**Sydney North Planning Panel Meeting 10 May 2023**  
**12-20 BERRY ROAD AND 11-19 HOLDSWORTH AVENUE, ST LEONARDS**

**Subject:** 12-20 Berry Road and 11-19 Holdsworth Avenue, St Leonards  
**Record No:** DA22/115-01 - 15540/23  
**Division:** Environmental Services Division  
**Author(s):** Greg Samardzic

<b>Panel Reference</b>	PPSSNH-339
<b>DA Number</b>	115/2022
<b>LGA</b>	Lane Cove Council
<b>Proposed Development</b>	Demolition of existing structures and construction of a mixed-use development containing two buildings comprising a total of 130 apartments (including one affordable dwelling), childcare centre, community facility and basement parking for 180 vehicles
<b>Street Address</b>	12-20 Berry Road and 11-19 Holdsworth Avenue, St Leonards
<b>Applicant/Owner</b>	Applicant: Hilary Apitz (Altis Bulky Retail P/L) Owner: SJD St Leonards P/L and Aqualand St Leonard Development 3 P/L as Trustee for Aqualand St Leonard Development 2 Unit Trust
<b>Date of DA lodgement</b>	26 September 2022
<b>Total number of Submissions</b>	Five
<b>Number of Unique Objections</b>	Five ( <b>Note: All copies of submissions sent to the Panel for review</b> )
<b>Recommendation</b>	<b>Refusal</b>
<b>Reg

**Figure 17 – Proposed Balcony Encroachments into the Required Green Spine Area**

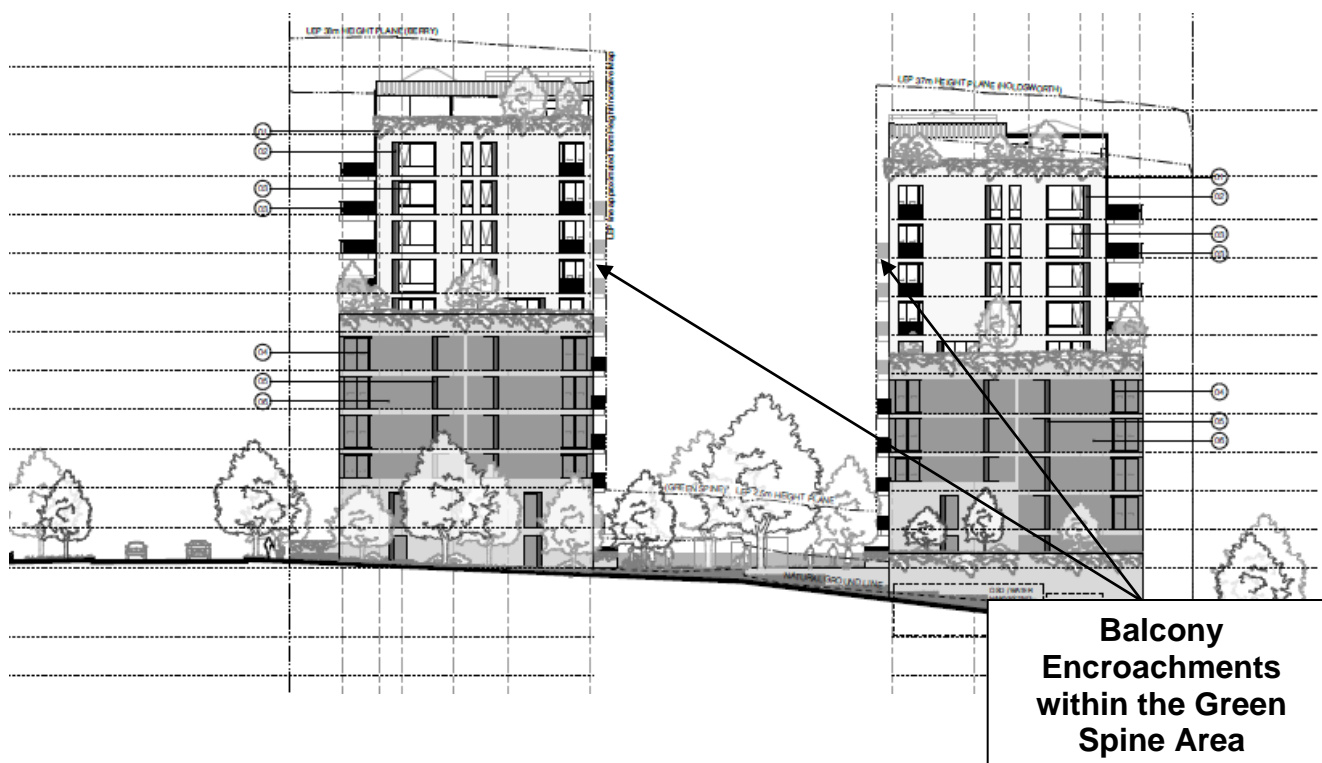
It is advised that the proposal contains balconies elements into the required 24m wide Green Spine Area and would be contrary to the maximum 2.5m green spine building height development standard under Clause 7.1(3)(a) of LCLEP 2009 (see Figure 15 above).

It was requested that these elements be deleted to ensure full compliance and in response the applicant had not deleted these encroachments. The applicant's justification is as follows:

**Comment:** Further to the above justifications, the applicant indicated at the meeting on 20 March 2023 that there were some cadastral LEP map inconsistencies that would made the proposal complaint with respect to height. It was stated that the blue coloured part of the LEP height map is below 24m in width as the map due to the thickness of the black lines. This argument by the applicant is not supported in principle as the intent of the green spine is to be a minimum 24m in width under the DCP and that there be no encroachments above 2.5m above natural ground level. It is noted that Clause 4.6(8)(cb) – Exceptions to development standards reads as:

The DCP and the associated Landscape Master Plan (LMP) states that a minimum 24m wide Green Spine Area be provided as part of any development. Under Part 7 – Built Form, the Building Envelope table: Control No. 2: Rear Building Setback requires a ‘*Minimum 12m setback to rear boundary of an Area*’. The proposed design outcome with balconies encroaching into the Green Spine Area and the applicant’s justification is not supported as other approved or proposed developments within the precinct have fully complied with this height requirement. Full compliance should be achieved, and these building elements be deleted as they cannot be approved.

**Figure 20 – Proposed Floor Plate of the Childcare Centre Level**

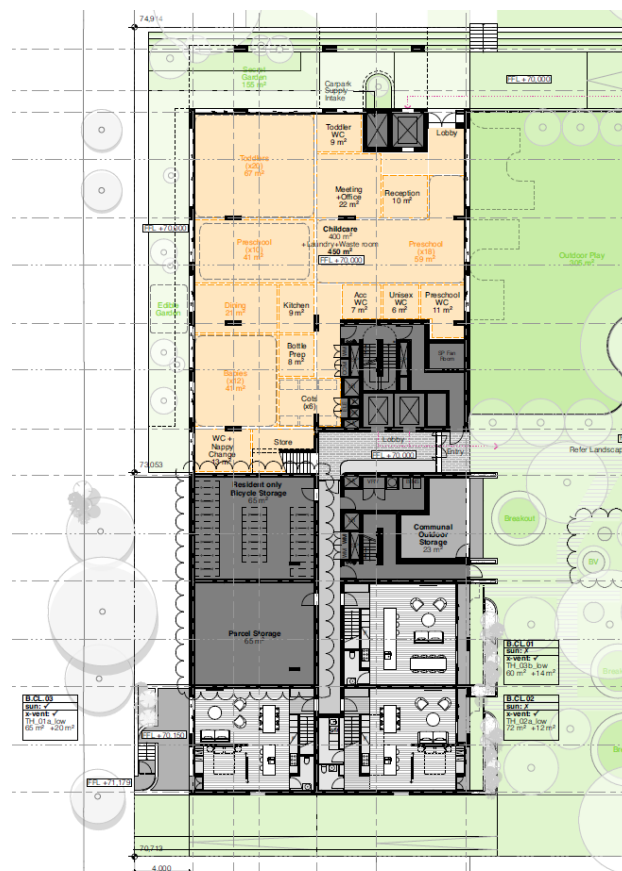
Further, the applicant is of the opinion that the proposed ground childcare level is a 'part storey' however it is Council's view that it does not constitute as a 'part storey' rather as a 'full storey'. This level is to be counted as a 'full storey' as more than 50% of the proposed floor plate is habitable (including the childcare spaces coloured in peach) as shown on the figure below.

The applicant was requested to redesign the proposal to comply with the maximum number of storeys controls and the applicant in response did not amend the proposal to comply. The applicant's justification is as follows:

**Figure 24 – Extent of Building Setback Variations to Holdsworth Avenue (Building to the Right) and Berry Road (Building to the Right)**

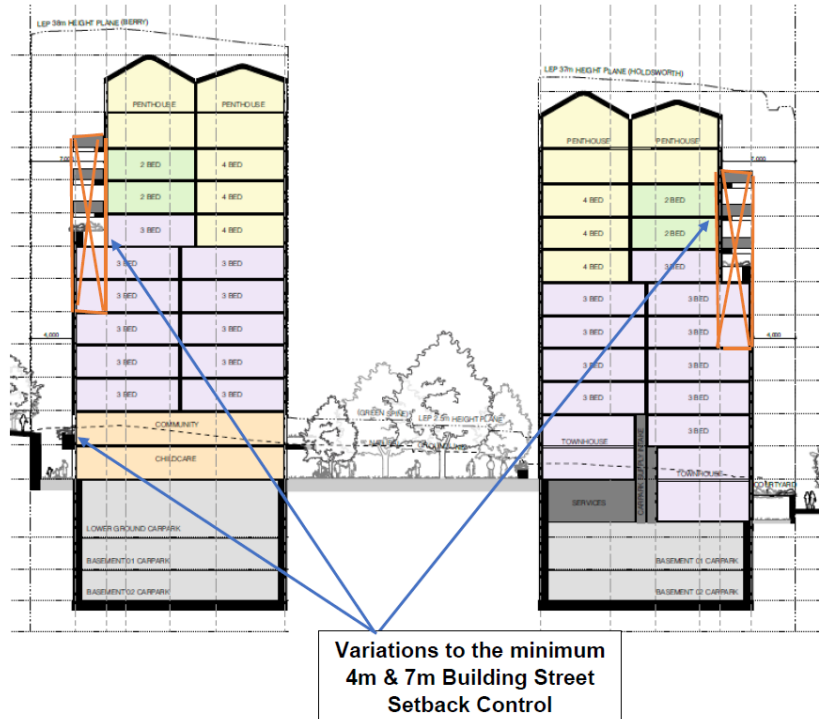
There are substantial variations being proposed to the required **minimum 7m setback** for both buildings **at Level 6 and above to Berry Road and Holdsworth Avenue** (see Figure 24). Further, there are substantial variations being proposed to the required **minimum 6m and 9m setback** for both buildings to 15m wide pedestrian link (see Figures 25 and 26).

Again, the applicant was requested to redesign the proposal to fully comply with the DCP setback requirements and the applicant had chosen not to do so. The applicant's justification is as follows:
